EXHIBIT 6

Address: 48-01 108th Street, Corona, NY 11368

Report Date: December 22th, 2023

Inspector: Hany Demetry, NYS Registered Architect - Lic#38321

Fig. 1.1 – Proposed ramp with non-compliant landing.

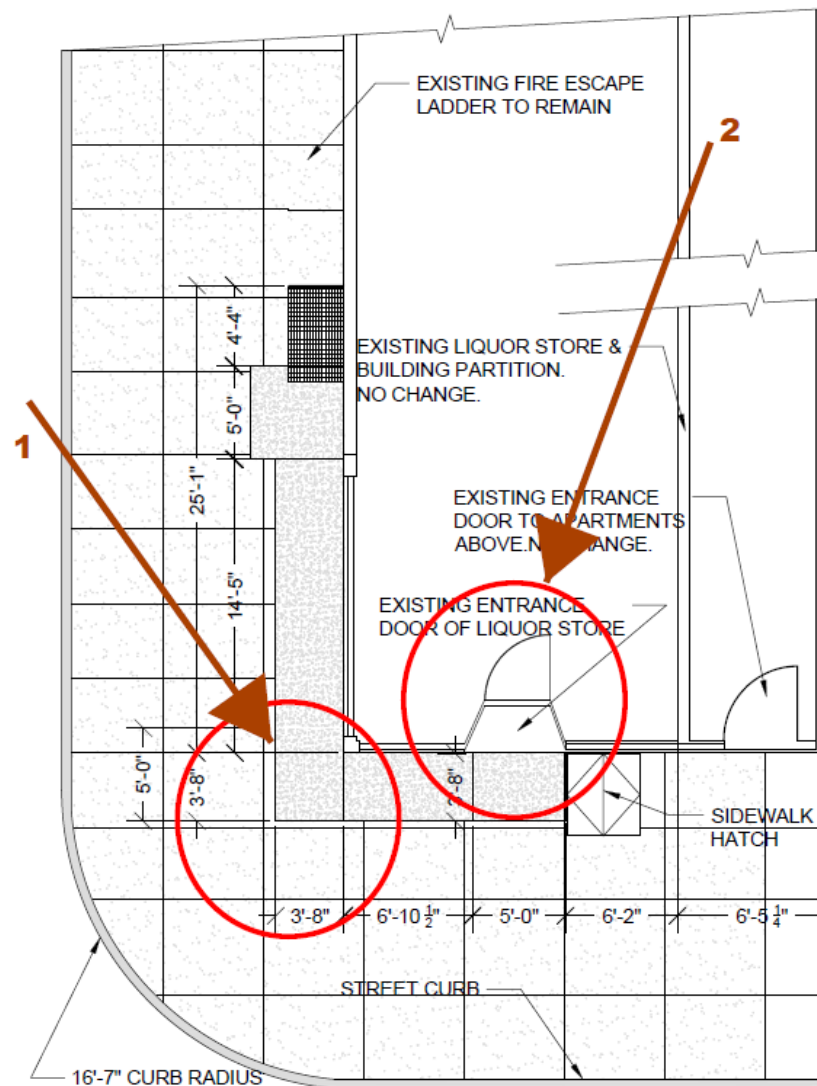
This hypothetical ramp is not in compliance with the ADA or the NYC Building Code. As set forth above, the maximum permitted projection on a city sidewalk under the ADA is 44" beyond the property line, on one street for corner lots. *See, e.g.*, 2022 NYC Building Code at § 3202.2. In order for this hypothetical ramp to change directions, a turn-around radius of 5'-0" is required to be provided. This means that the proposed intermediate landing must be 5'-0" x 5'-0" at least (not 3'-8" x 3'-8", as proposed). Therefore, the 5'-0" (*i.e.*, 60") projection on the sidewalk is beyond the 44" maximum permitted projection. *See Fig. 1.1, Fig. 2.*

The architectural plans, dated September 6, 2023, referenced in the Dobrova Aff. and the Supp. Esquenazi Aff., do not address the Premises' existing entrance door. *See Fig. 1.2.* Assuming *arguendo* that the hypothetical permanent ramp is technically feasible (it is not), there is no feasibility analysis as to its impact on the existing entrance, and the layout of the Premises. *See Fig. 1.2, Fig. 3.* Under this proposed plan, a full renovation of the interior layout of the store will be required, as more clearances will be required on the interior of the store. *Id.* This could detrimentally impact the commercial viability of the Premises.

Fig. 2 – Diagram showing that a ramp for ADA accessibility will block the residential apartments entrance, and will extend into the adjacent property.

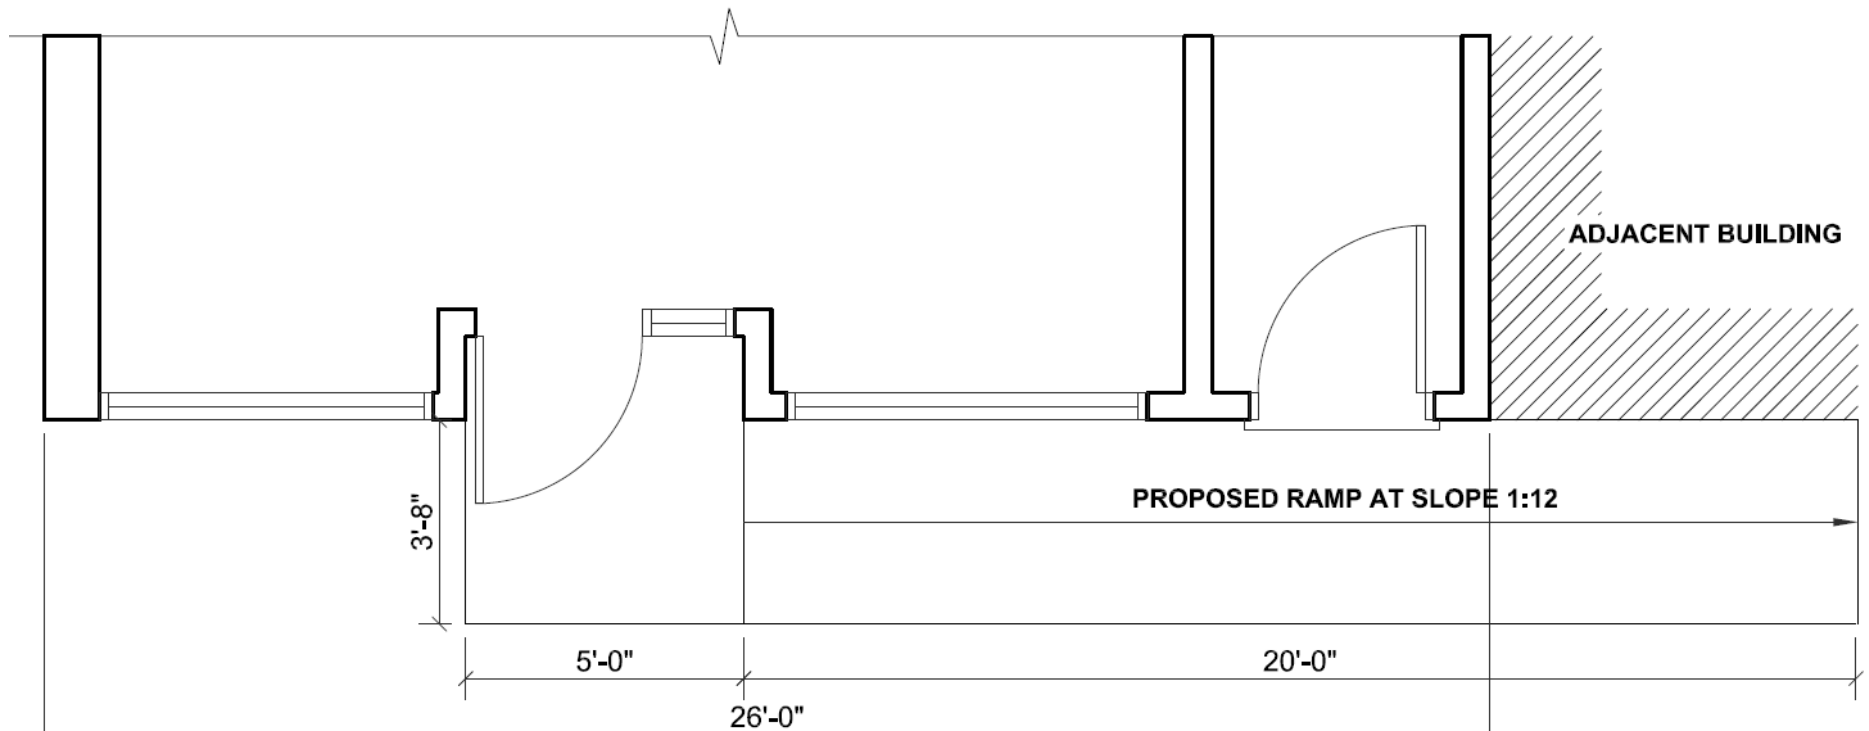
To make the entrance accessible, the required ramp would need to have a maximum slope of 1:12, meaning a 1'-0" of plan dimension to every 1" of drop, with a maximum run or 30'-0" without a landing. This would require a 20'-0" ramp. This hypothetical ramp is not technically feasible, as it is only allowed to project 44" on the sidewalk, and will have to stretch along the 108th street frontage. *See Fig. 1.1, Fig. 2.* Here, the existing frontage of the building is only 26'-0". *Id.* This will lead to ramp stretching beyond the property line and provide an entry point from the adjacent property, which is not legal. *Id.*
